ROCKER ARM SHAFT

Application of Modifications

Fig. 1 (1) Cylinder head cover
(2) Sealing washer
(3) Right rocker arm shaft
(4) Left rocker arm shaft

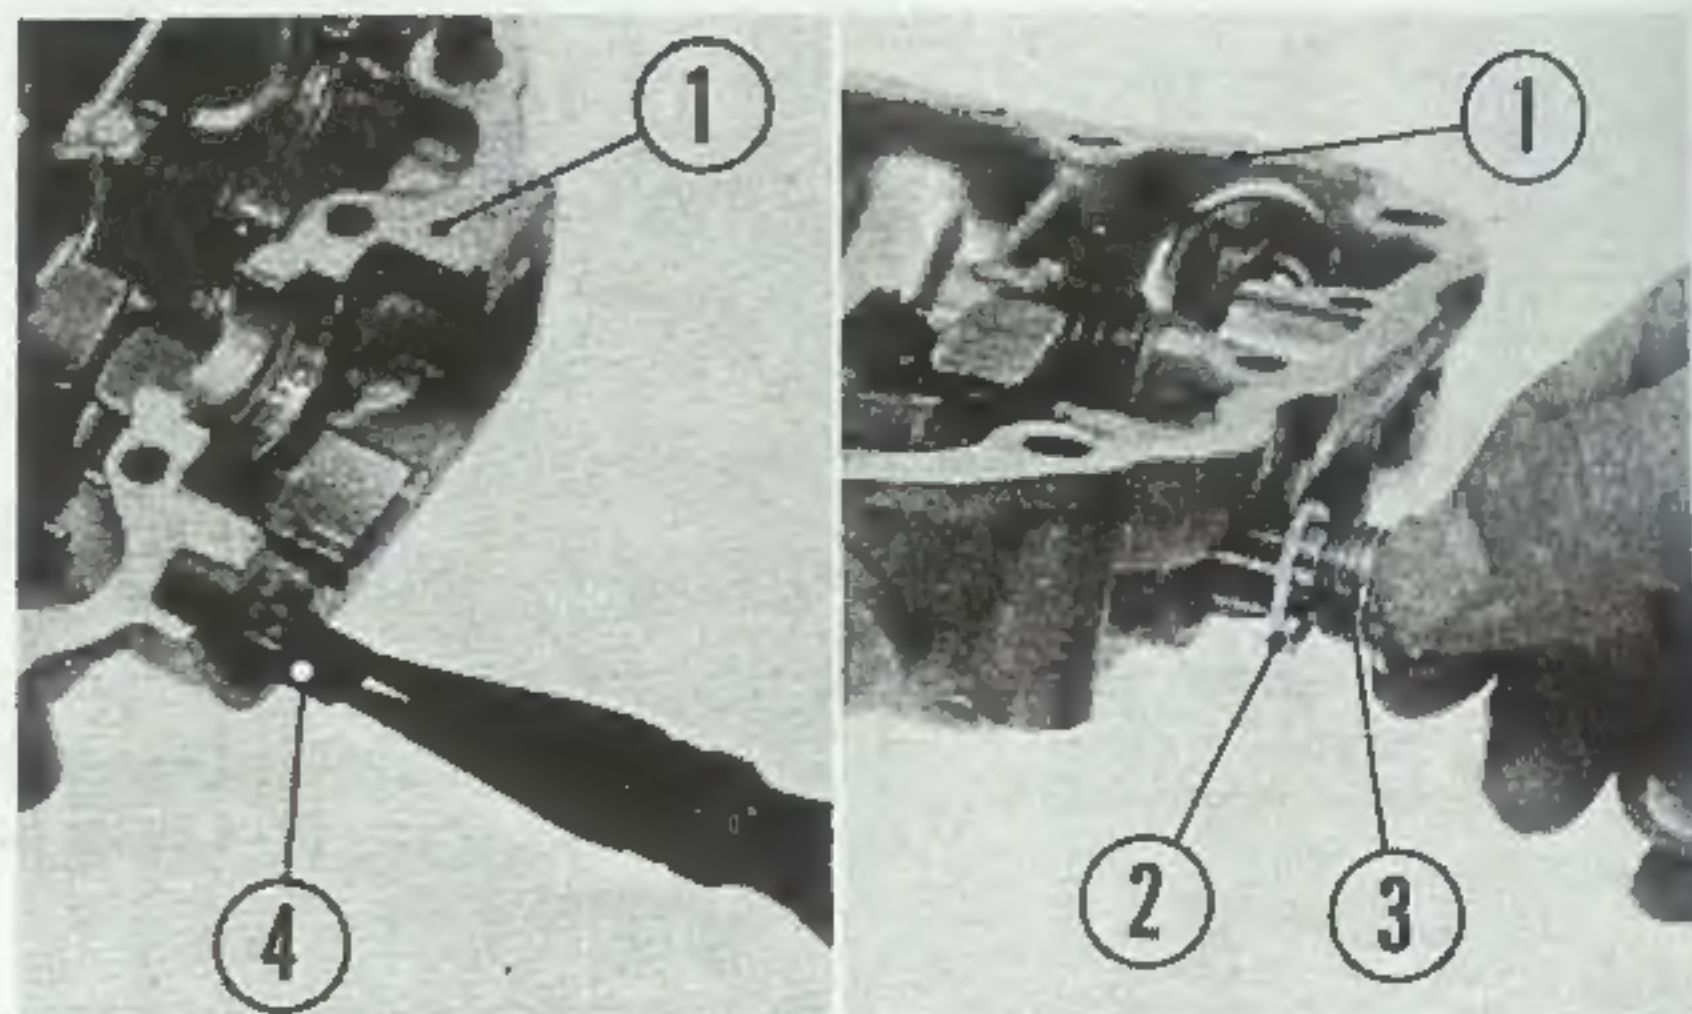
This changes have been applied on the production models starting with the following engine serial numbers.

TYPE	ENGINE No.
CB250 K5/G	6022201
CB360G	1088381
CL360K1	2008449
CB360T	2031164

Except that Right rocker arm shaft is removed only loosening bolt.
